Compatible-Scale Infill Housing (R-2 Zones) Project

PZC Case No. 2019-009

Public Hearing Draft – Supporting Exhibits
for Public Hearing on March 4, 2019

This Comment-Issue Response documents the Planning Department’s responses to the public comments regarding the *Compatible-scale Infill Housing (R-2) Zones amendment*, September 27, 2018 Community Discussion Draft. The responses help show the basis for the Public Hearing Draft which was released on December 10 and that is scheduled for a March 4, 2019 PZC public hearing.

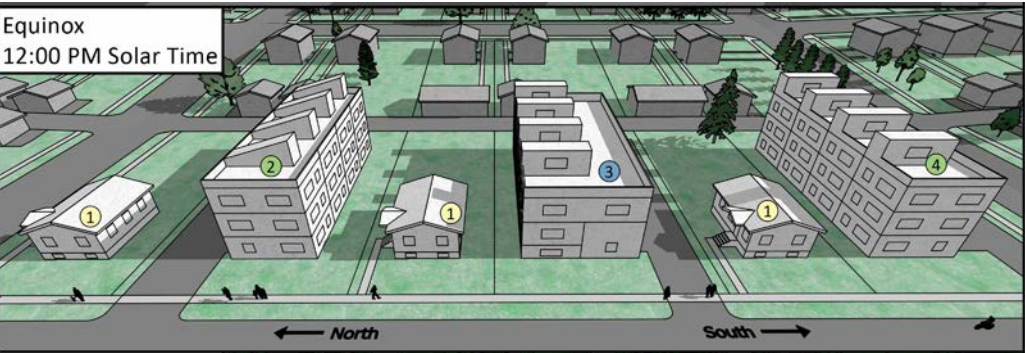
Item #	Comment or Issue	Response and Recommendation
		<p>This means that allowing the greater development flexibility of 3 stories only on larger lots could incentivize a sprawling pattern of development that does not use existing infrastructure efficiently.</p> <p>Potential Bulk and Shadow Effects of Applying a 2.5-story Limit Only on Smaller Lots; and Not Applying a Solar Access Step-back, in R-2M Zone Lot Size Threshold Scenario: Lots Less than 14,000 Square-feet are Subject to 2.5-Story Limit</p>  <p>① Existing Older Home on 7,000 Square-foot Lot ② 2-story Four-plex with Basement on 11,200 Square-foot Lot, Subject to 2.5-story Height Limit in this Scenario ③ 3-story Five-plex on 14,000 Square-foot Lot, Exempt from 2.5-story Height Limit in this Scenario</p> <p>3. There are inherent problems with the 2.5-story standard, regardless of what lot size it is applied to. As discussed in issue 1-a, the current 2.5-story standard limits design flexibility and does not ensure a consistent maximum building height or level of sunlight access protection for neighbors. For example, the illustration on the next page shows that the 2.5-story standard (shown on fourth building from left) could result in bulkier buildings than the proposed R-2 amendment’s maximum building size.</p> <p>Restricting architectural style is not consistent with the 2040 LUP policy to allow more innovative housing types. The photo from the 2040 LUP land use designation that the R-2M district implements (photo provided at end of issue 1-a, left column) a three-story modernist infill housing development can fit in with the scale and form of its single-family neighborhood environment.</p>
